PLANNING CLEARANCE

GRAND JUNCTION PLANNING DEPARTMENT

PLANNING CLEARANCE COMMENTS
Guardian Storage 497 28 1/2 Road

GUARDIAN STORAGE
28 1/2 RD. GRAND JUNCTION, COLO.

LANDSCAPE PLAN

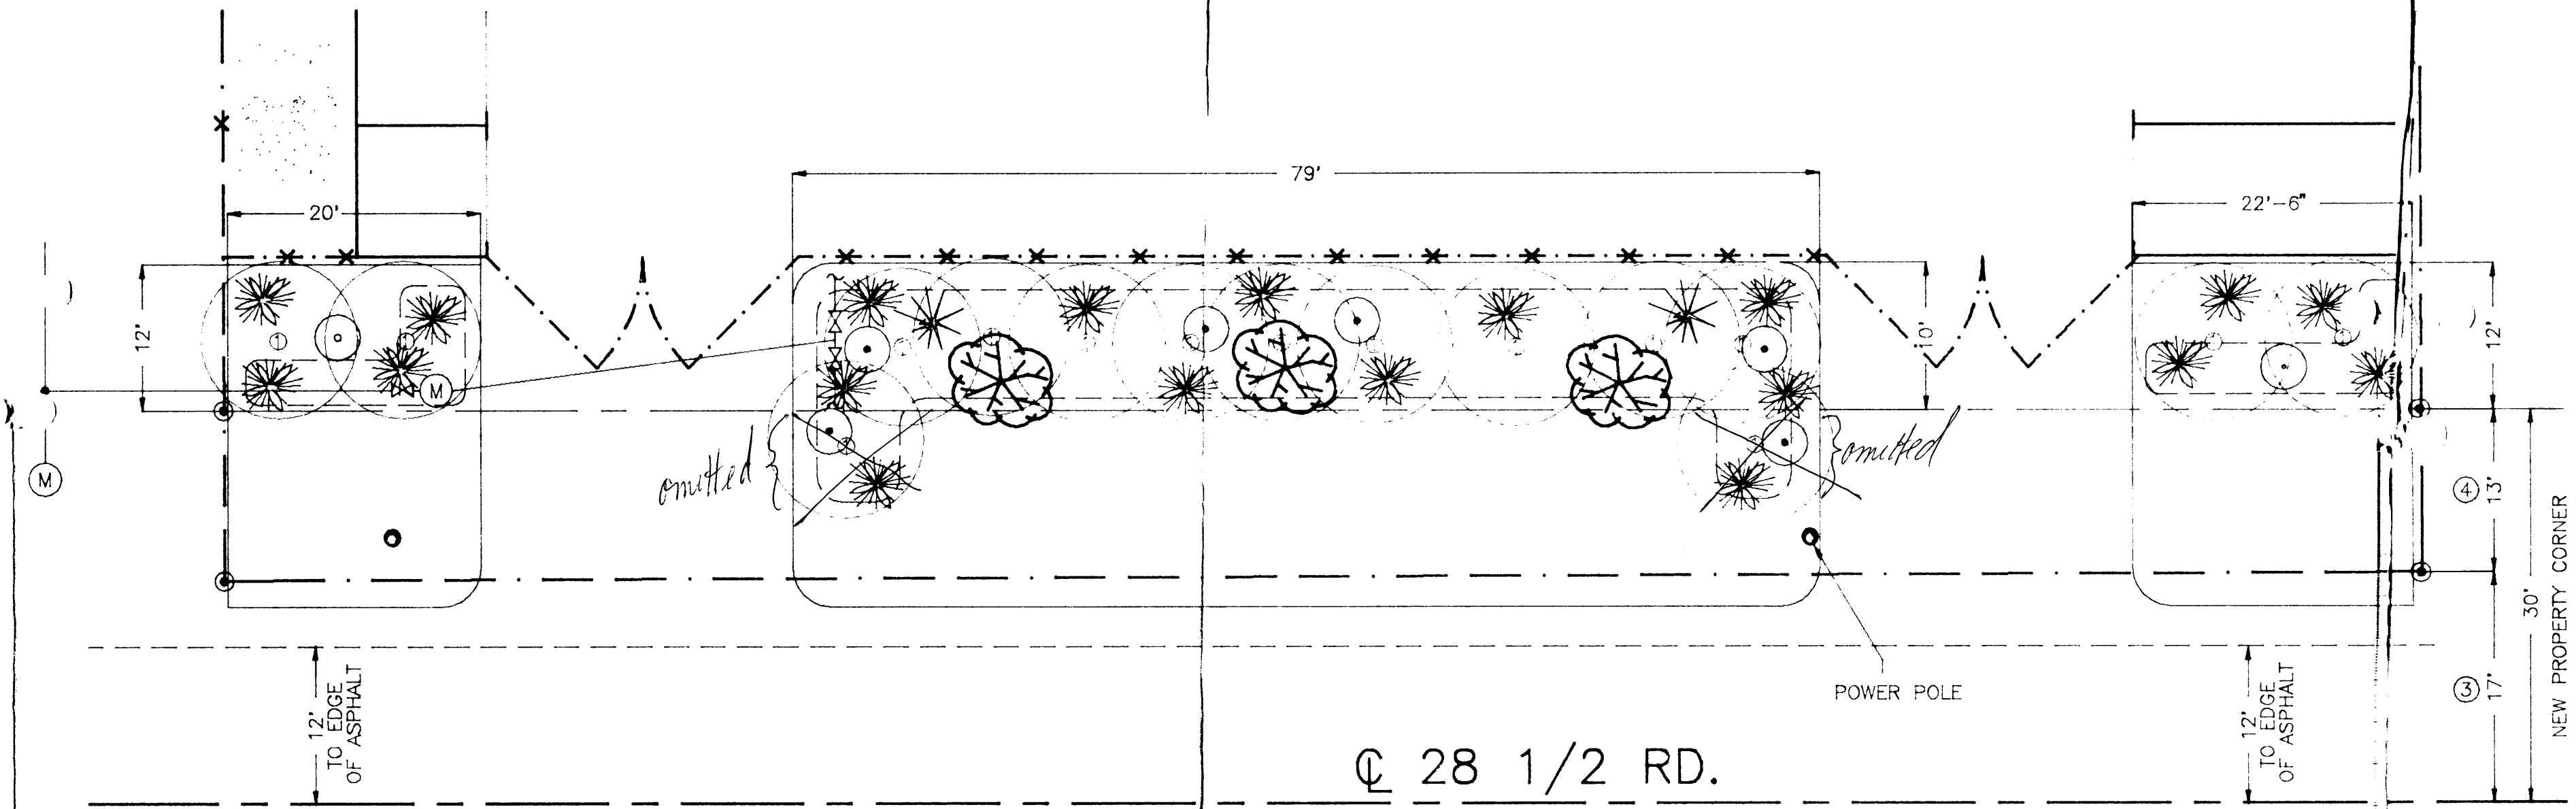
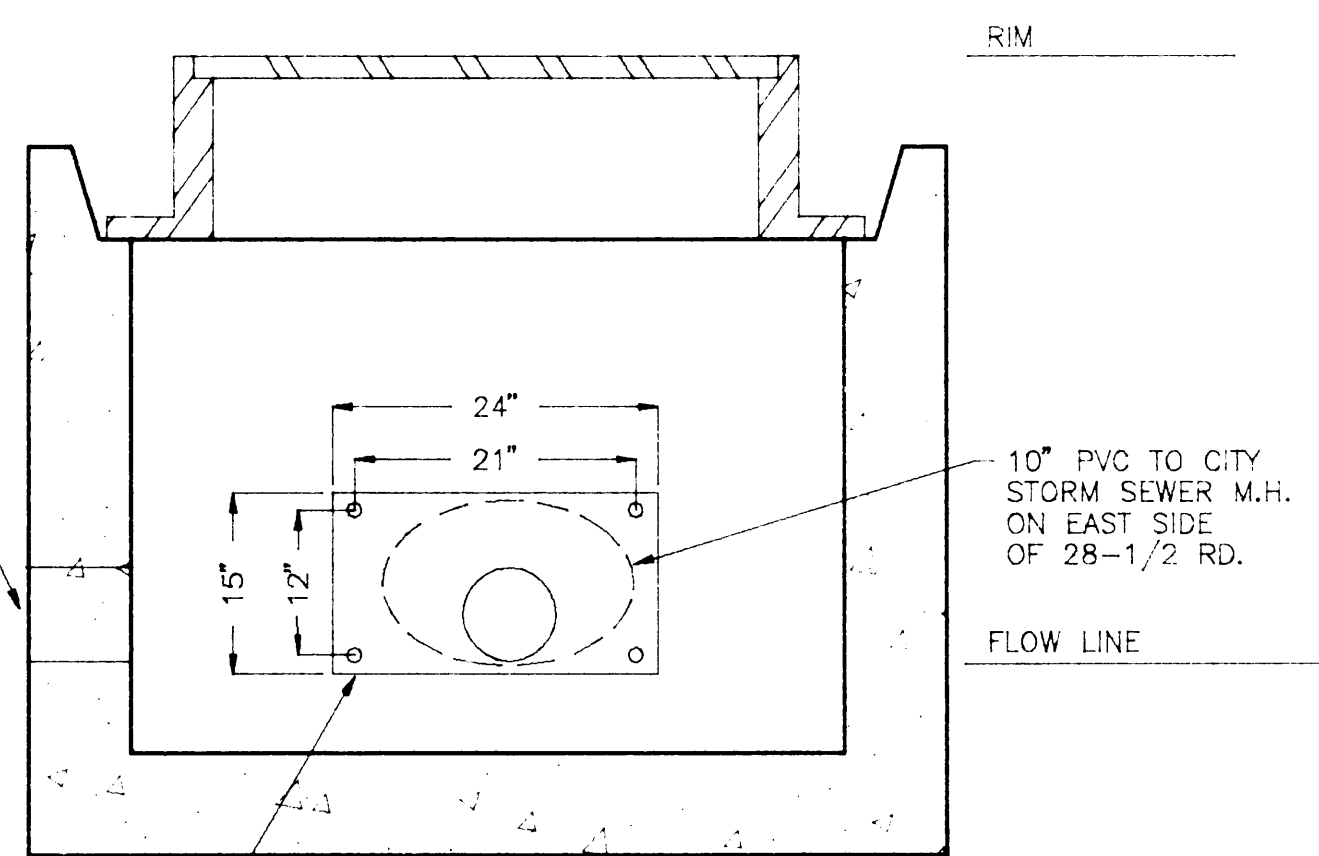
- ok
4. 1,267 square feet of landscaped area is required. I calculated 1,068 square feet of landscaped area shown on the landscaping plan. 506 square feet of the required landscaped area must contain shrubs. What is the proposed ground cover? Underground pressurized irrigation must be available for all landscaped areas.
 5. A fence permit will be required. *- record 4/1/91*
 6. A sign permit will be required for any signs.
 7. All driving surfaces must be paved. *required*

SITE PLAN
SCALE: 1/8" = 1'-0"

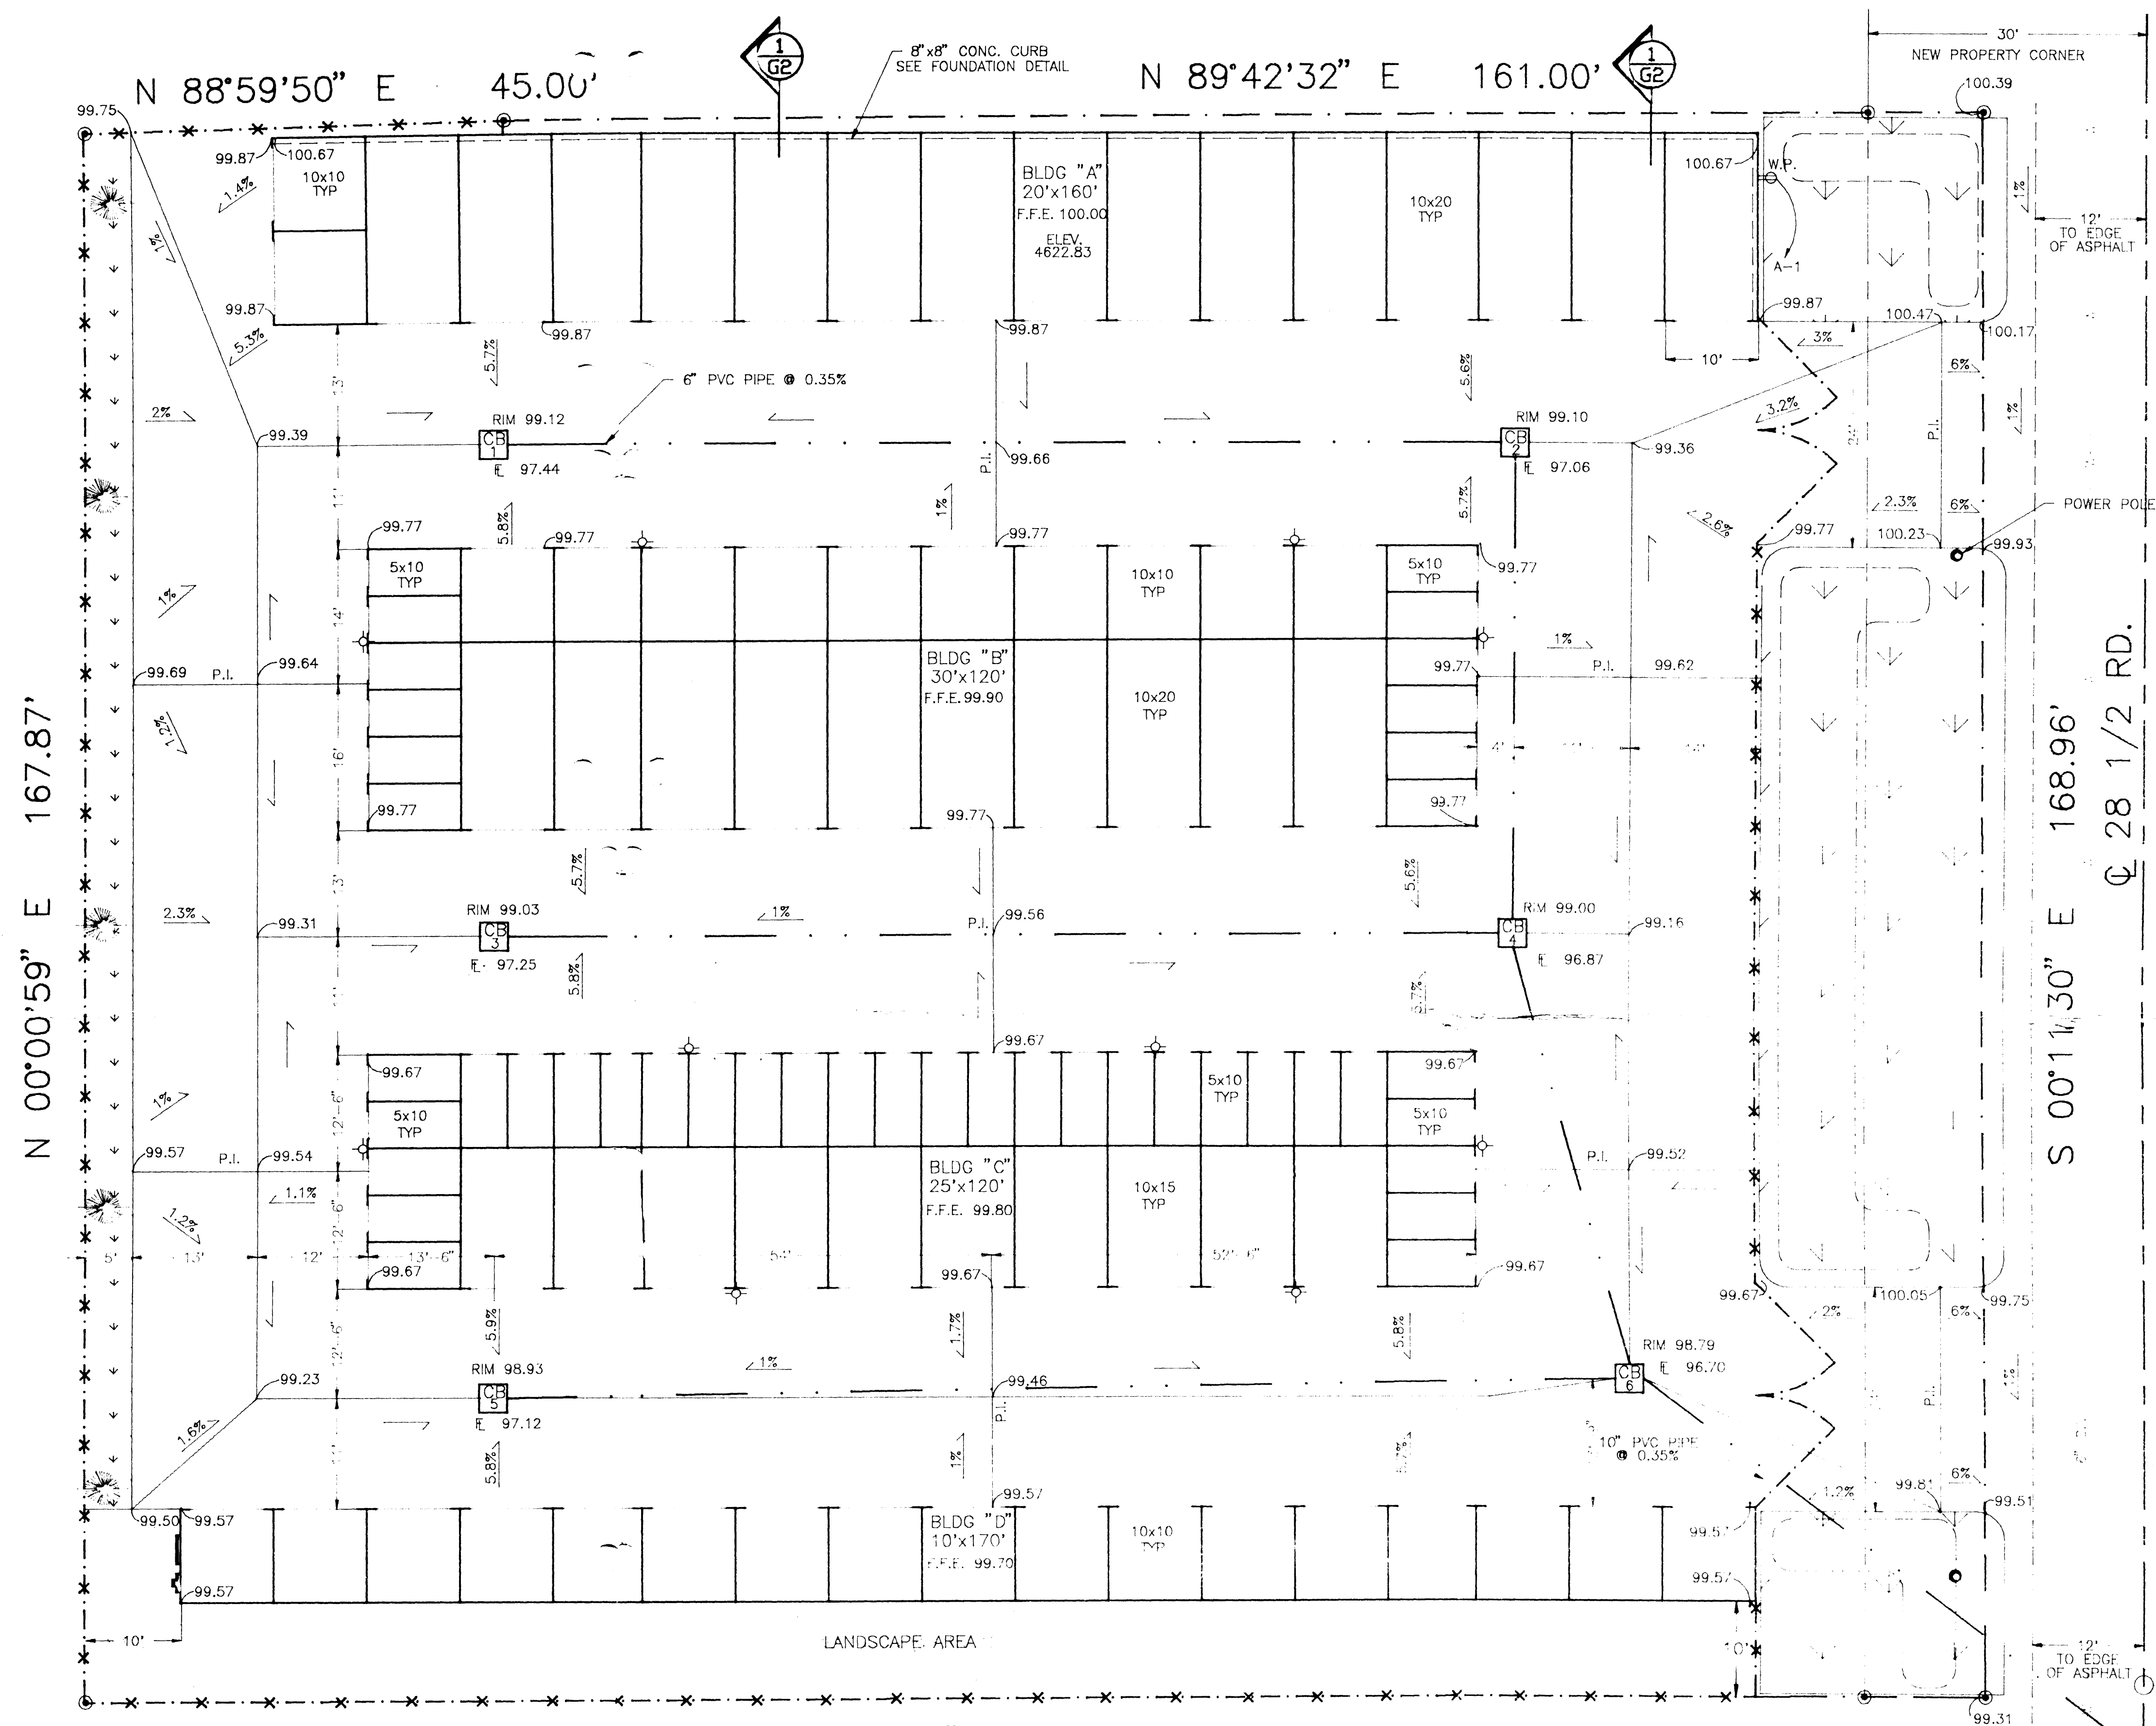
- OK 1. Plans show manhole in 28 1/2 Road to be 22.8' deep. This can't be!
- OK 2. Show profile or depth of storm drain crossing 28 1/2 Road. If less than 30" of cover over pipe, use concrete pipe or encase P.V.C. pipe in concrete. (See City specs for storm drains)

- OK 3. Minimum size pipe crossing 28 1/2 Road shall be 10" for maintenance purposes.
- OK 4. Storm discharge from site to existing storm drain in 28 1/2 Road shall be limited to 10 year flow rate for undeveloped conditions. The discharge rate should be limited at the inlet located at the southeast corner of property.

- OK 5. Need drainage calculations using modified rational method to determine on site detention volume and maximum runoff rate from the site.
6. A permit shall be obtained for all work in public right-of-way. ~~Redesignated not necessary~~ Agreed

7. A revocable permit will be required for landscaping and other improvement in the right-of-way. ~~Redesignated not necessary~~
8. A street cut permit will be required from my office for installation of storm drain pipe across 28 1/2 Road. Agreed

- OK 9. Show existing utilities/conflicts in 28 1/2 Road.

1. The additional right-of-way required along 28 1/2 Road must be dedicated to the City prior to issuance of the Planning Clearance. Please contact Tim Woodmansee, City Property Agent, at 244-1565. ~~Contact made - ROW must be dedicated prior to issuance of P.C.~~
2. Landscaping within the right-of-way requires a revocable permit. Contact Tim Woodmansee at 244-1565. ~~Redesignated - not necessary~~
- OK 3. The two corner landscaped areas should be "flip-flopped" so the majority of the landscaped area is on private property.
